Campo Del Sol Unit 2B

City Plan Commission — June 5, 2025

| CASE NUMBER/TYPE: | SUSU25-00043 – Major Combination |

Figure A: Proposed plat with surrounding area

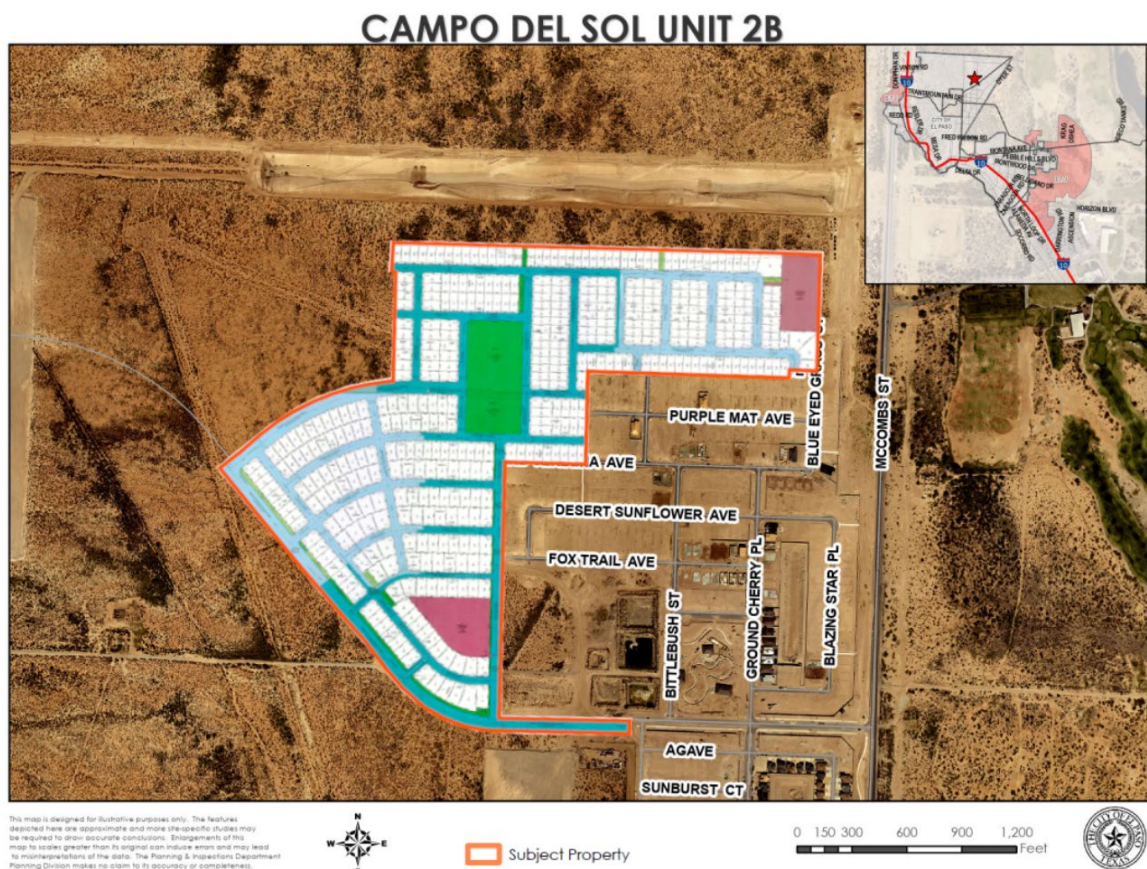
SUMMARY OF RECOMMENDATION: Staff recommends **APPROVAL WITH CONDITION** of Campo Del Sol Unit 2B on a Major Combination basis, and **APPROVAL** of the exception requests.

- That the applicant landscape the rear of all double-frontage lots, in accordance with Section 19.23.4(H)(3)(c) of the El Paso City Code.

PROPOSED CROSS-SECTION:

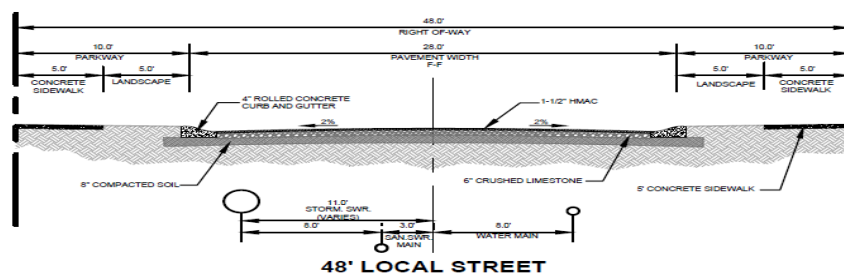
2. To waive the dedication of twelve feet (12') of additional right-of-way, the construction of ten feet (10') of additional roadway, and one foot (1') of sidewalk for a local street within the subdivision.

EVALUATION OF EXCEPTION REQUEST: The exception requests to waive right-of-way improvements meets the following criteria under El Paso City Code 19.10.050(A)(1)(a) – (Roadway Participation Policies—Improvement of Roads and Utilities Within and or Abutting the Subdivision). The section reads as follows:

a: Fifty per cent of the lots within a quarter mile of the proposed development have already been developed and the existing street improvements are in character with the neighborhood. The proposed cross-section for a local street is a design that matches the existing and already developed cross-sections abutting the proposed subdivision.

ATTACHMENT 2

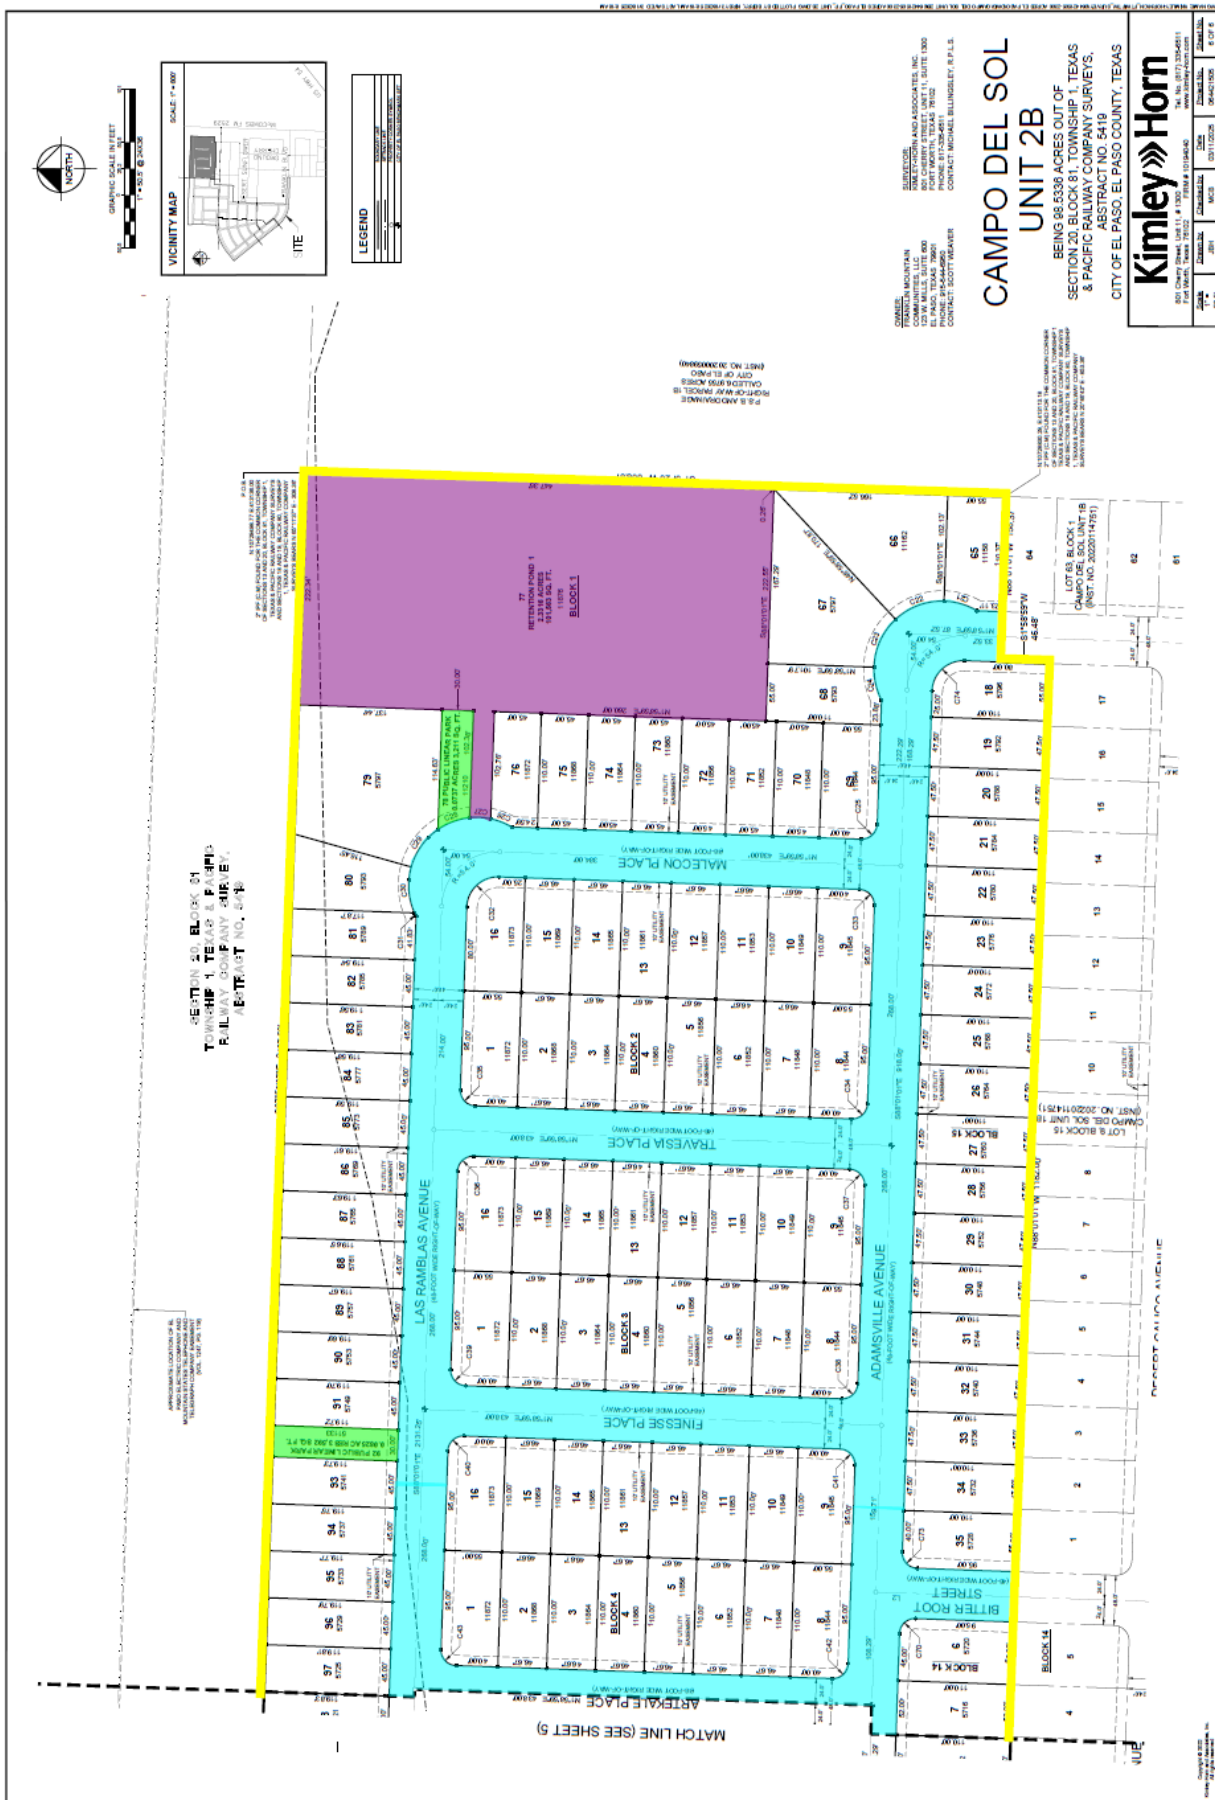
1. Submit to the Planning & Inspections Department – Planning Division the following prior to recording of the subdivision:
 - a. Current original tax certificates with zero balance.
 - b. Original copies of the Restrictive covenants.
2. Remove plat note #3 as the required information is included on plat note #12
3. Staff recommends to the City Plan Commission (CPC) that the applicant landscape the rear of all double-frontage lots, as per section 19.23.040(H)(3)(c) of the applicable Subdivision Code.

1. City Of El Paso Benchmark labeled wrong shall be City Of El Paso proposed **monuments**.
2. On Final plat Owner's Dedication and Acknowledgment. Verify County Of Dallas shall be County Of El Paso.
3. Verify note #5 and #8 maintained by "El Paso Municipal Management District No. 1".
4. Provide radius dimension for temporary turnaround and turning heels.
5. Provide print-out of the mathematical closure of the exterior boundary of the subdivision indicating the error of closure.
